Development Management – Delegated Officer Report

Application Number: AWDM/0412/25 **Recommendation: APPROVE**

Site: 15 Ellis Avenue, Worthing

Proposal: Amended description **-** Single-storey rear infill extension, new dormer on south side and new gablet to front elevation to existing loft conversion.

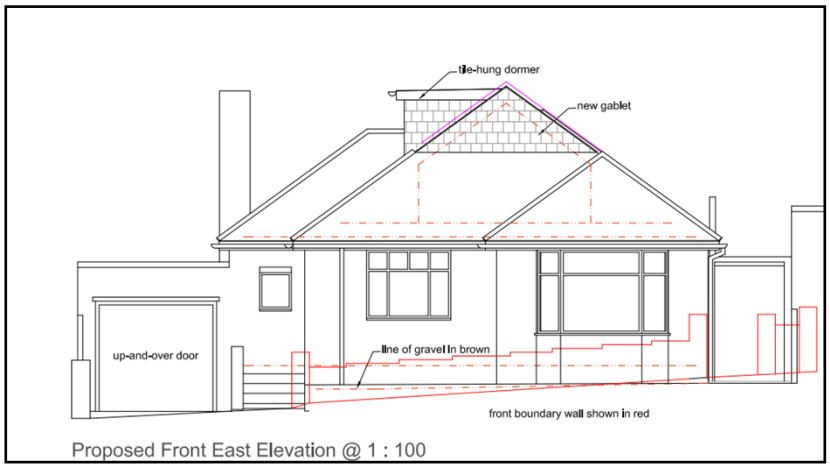
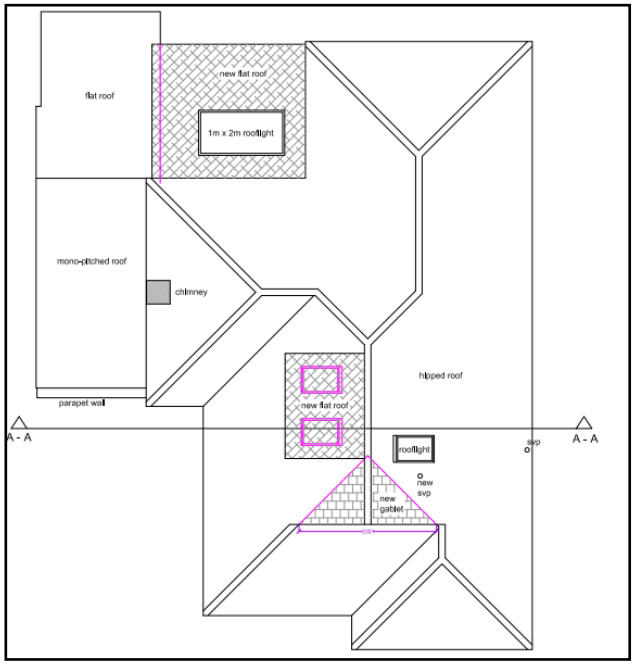
The application has been amended following concerns that the original plans proposing a large pitched roof front dormer would be overbearing and relate unsympathetically with the front hipped roof. The revised plans shown below are more sympathetic and incorporate a gablet front extension replacing the large dormer and a more modest flat roof dormer to the south elevation.

The small gablet extension matches a similar gablet to a hipped roof to the south and avoids a large bulky dormer on the front elevation (there are few dormers on the front elevation in this road). There are other examples of side flat roof dormers and the revised plans now reduce the size of the flat roof dormer on the south elevation. In design terms the amended plans are acceptable.

In terms of neighbour impact it is not considered the extension has any adverse impact on the amenities of neighbouring residents. Whilst the dormer would look southwards it would look directly onto (and over) the pitched roof of the property to the south (which is lower due to the sloping nature of the land). The infill extension would also not have any adverse impact being located between an existing garage and rear extension.

The revised plans are considered acceptable and the scheme now proposes sympathetic extensions to increase the usable floorspace within the roofslope.
